CITY OF FERNANDINA BEACH ADDENDUM NO. 3 ITB 19-05 AIRPORT OFFICE DEMOLITION AND HANGAR REHABILITATION

Exhibit 1 - Site Plan

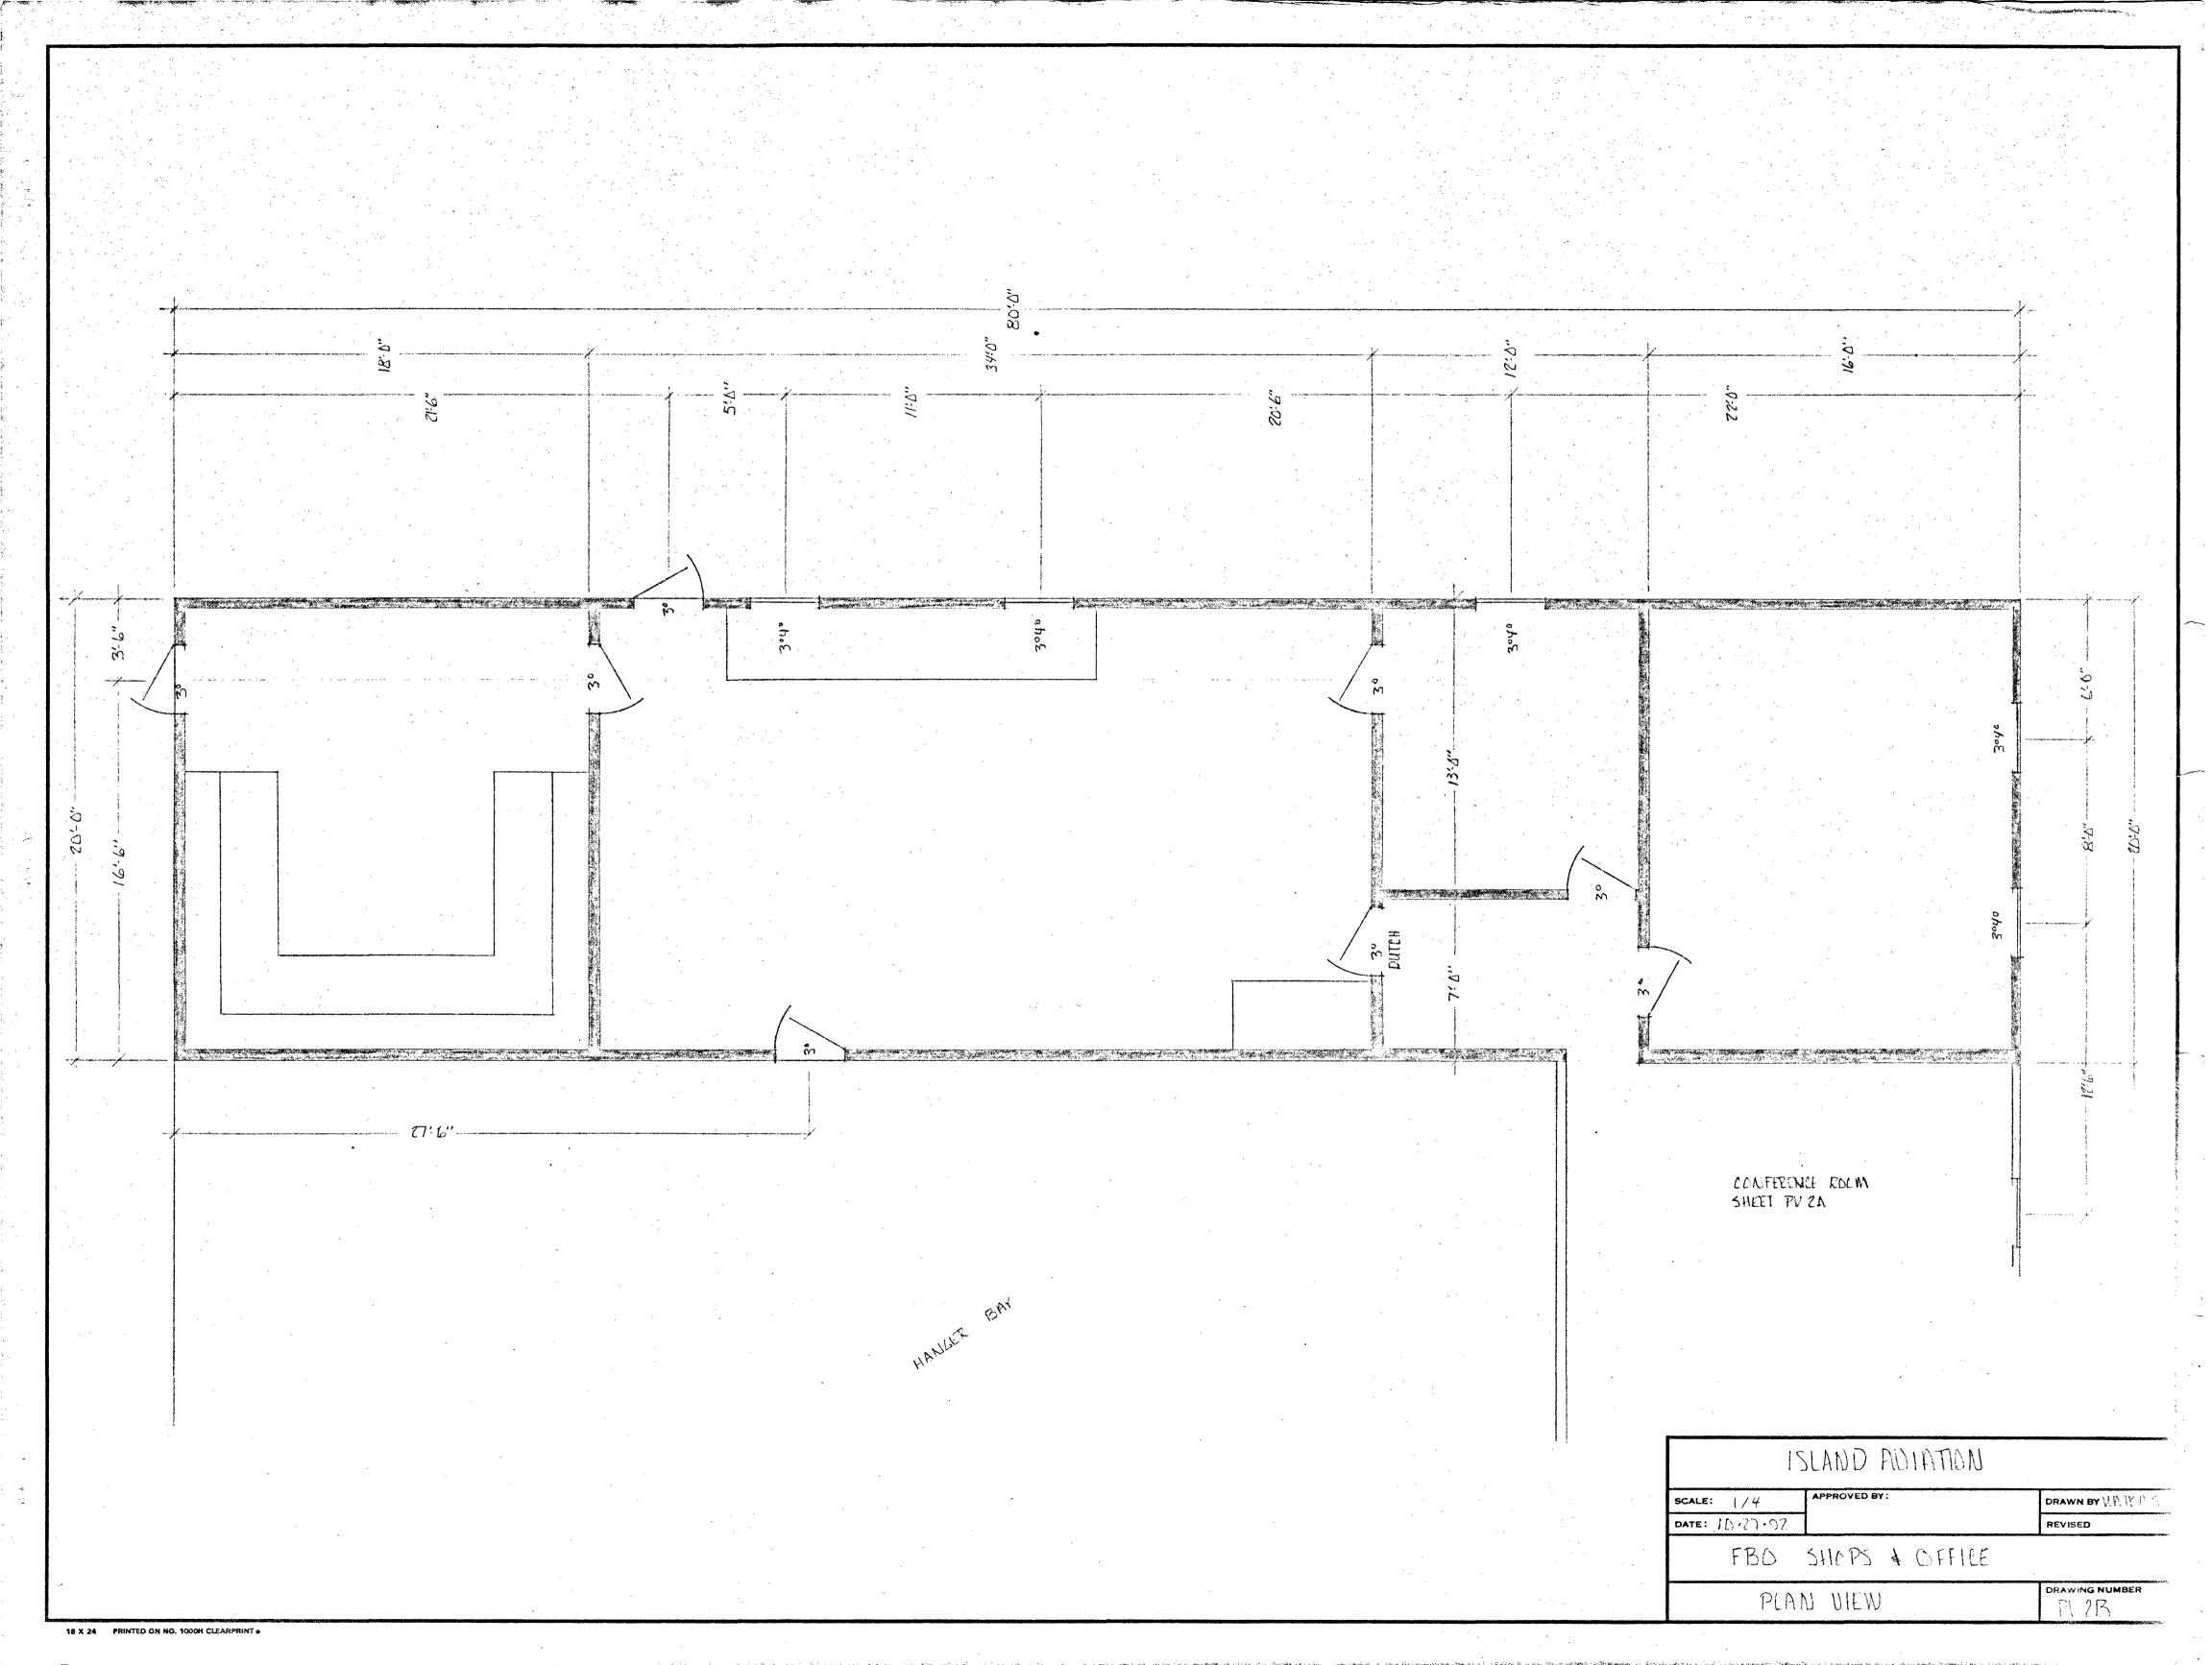
- 8. During the pre-bid meeting, a question was asked as to how far back debris fencing could be placed from the building. This fencing can be placed approximately 50' from the building as depicted on the site plan at Exhibit 1, however the exact location and layout of this fencing will be determined in coordination between the Contractor and City prior to construction activity on the airport.
